**TAXIWAY LIMA EXTENSION AND DECOMMISSIONING OF GA RUNWAY 4R-22L AND TAXIWAY ECHO
BATON ROUGE METROPOLITAN AIRPORT**

ADDENDUM NO. 3

DATE ISSUED: JULY 24, 2024

1
TS5
PAVEMENT LIP DETAIL
SCALE: NOT TO SCALE
NOTE: RIGHT SIDE SIMILAR, BUT MIRRORED

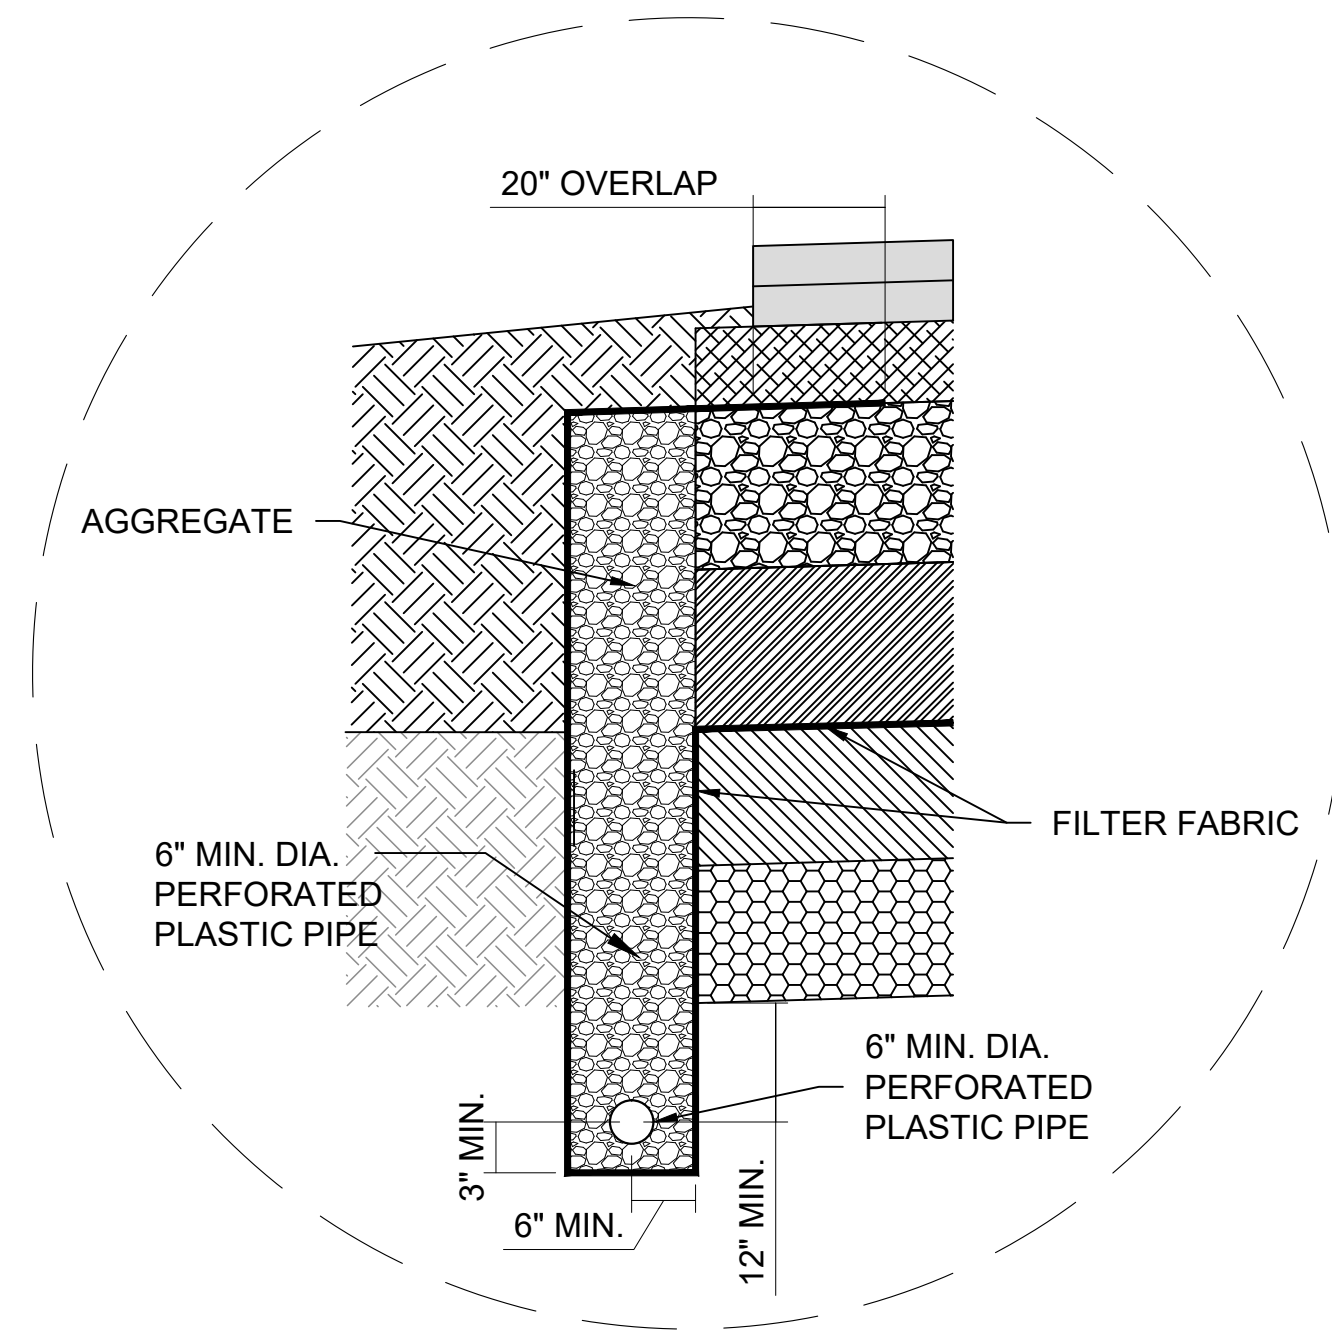
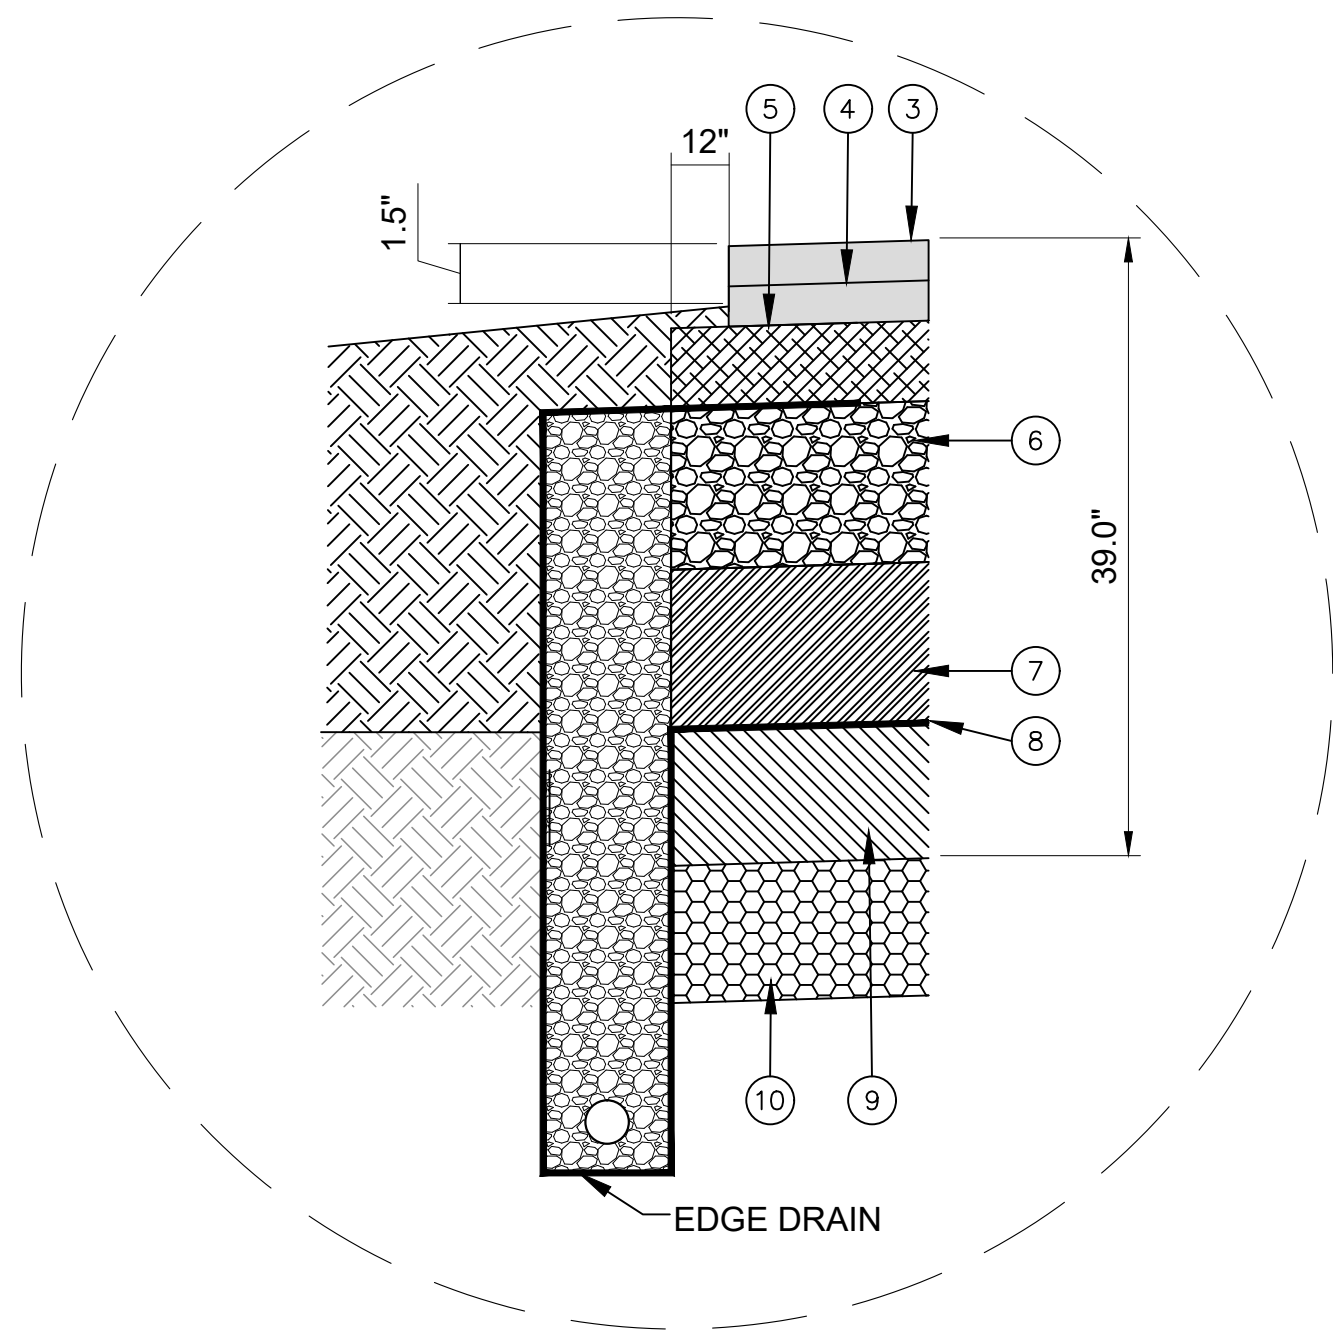
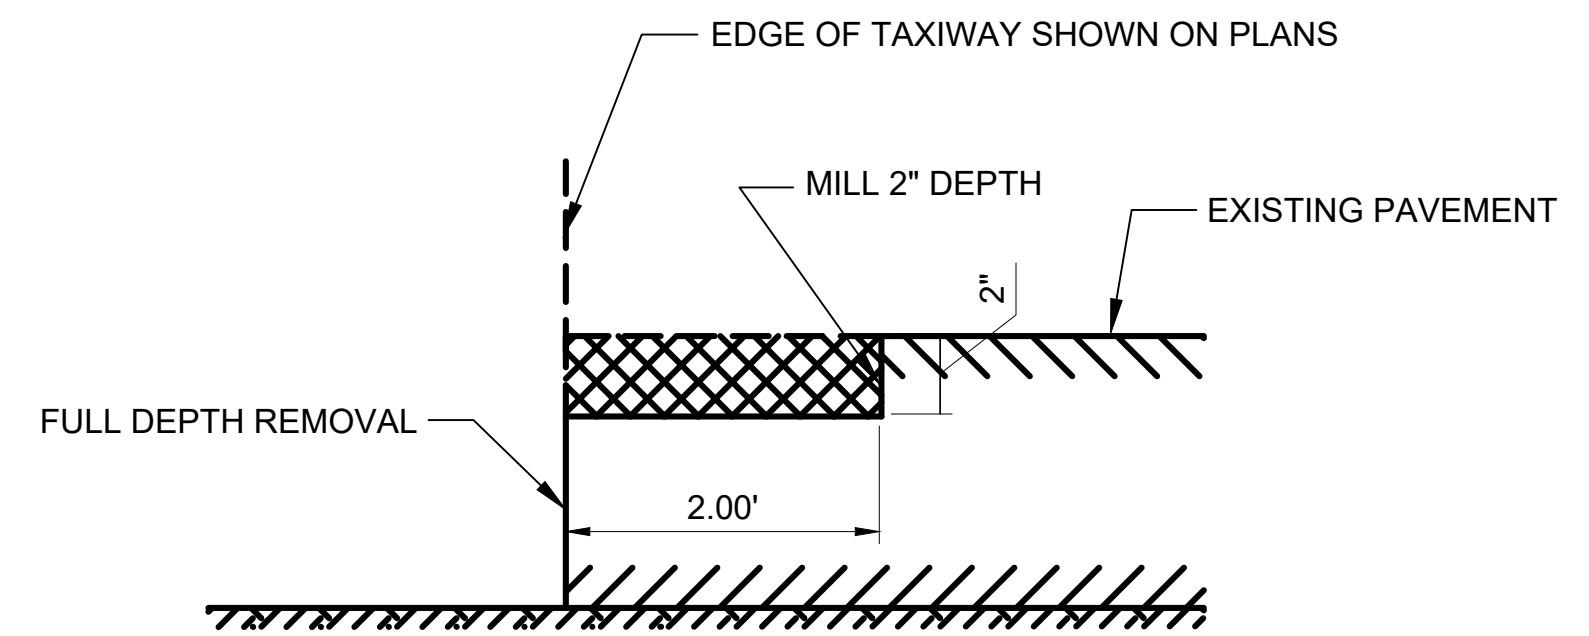
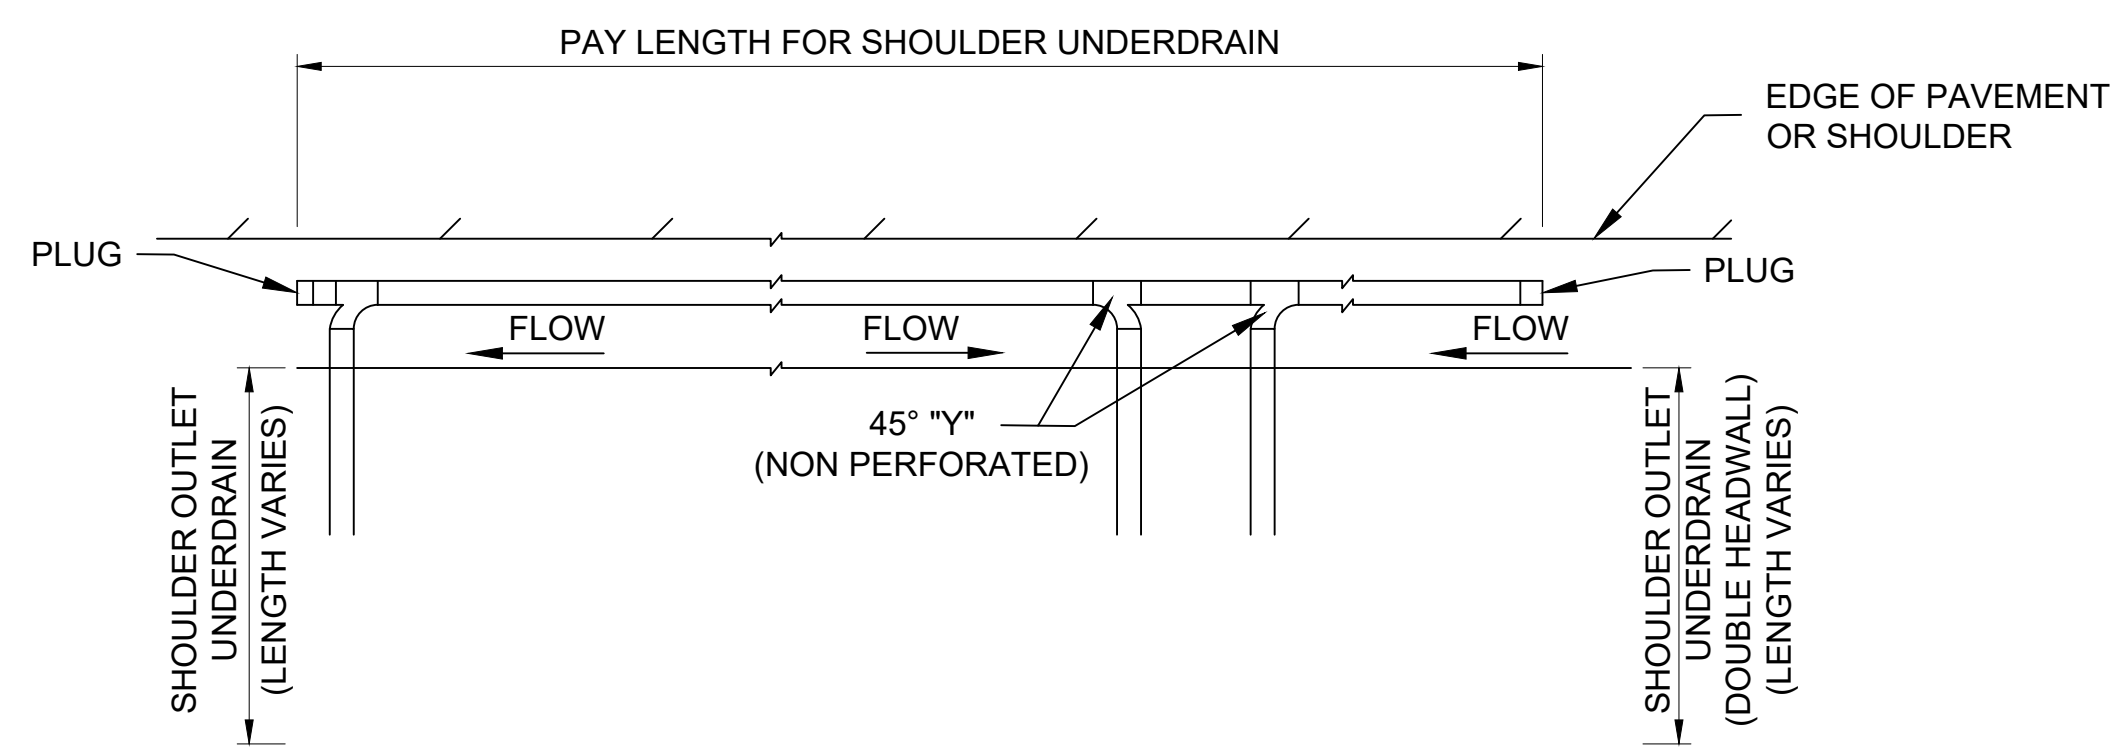
2
TS5
EDGE DRAIN DETAIL
SCALE: NOT TO SCALE
NOTE: RIGHT SIDE SIMILAR, BUT MIRRORED

3
TS5
TRANSITION TO EXISTING PAVEMENT DETAIL
SCALE: NOT TO SCALE

4
TS5
DUAL OUTLET LAYOUT DETAIL
SCALE: NOT TO SCALE

- NOTES:**
1. CONTRACTOR SHALL REMOVE STANDING WATER FROM THE SUBGRADE DURING CONSTRUCTION BY GRADING, DITCHING, PUMPING, OR WHATEVER MEANS ARE NECESSARY TO KEEP THE SUBGRADE DRY.
 2. SEE PLANS AND GEOMETRIC LAYOUT SHEETS FOR EXACT WIDTHS OF PAVEMENT, TSA, AND TOFA AT VARIOUS LOCATIONS.
 3. SEE PROPOSED GRADING SHEETS AND CROSS SECTIONS FOR GRADING DETAILS.
 4. LONGITUDINAL EDGE DRAINS SHOULD OUTLET INTO CATCH BASINS AT 400' MAX INTERVALS USING 6" NON-PERFORATED PLASTIC PIPE.
 5. THE PAVEMENT UNDERDRAIN SYSTEMS PAY ITEMS SHALL INCLUDE ALL REQUIRED TRANCHING, PLASTIC UNDERDRAIN PIPE (PERFORATED AND NON-PERFORATED), "Y" S, FITTINGS, PLUGS, GEOTEXTILE FABRIC, AGGREGATE, AND BACKFILL.
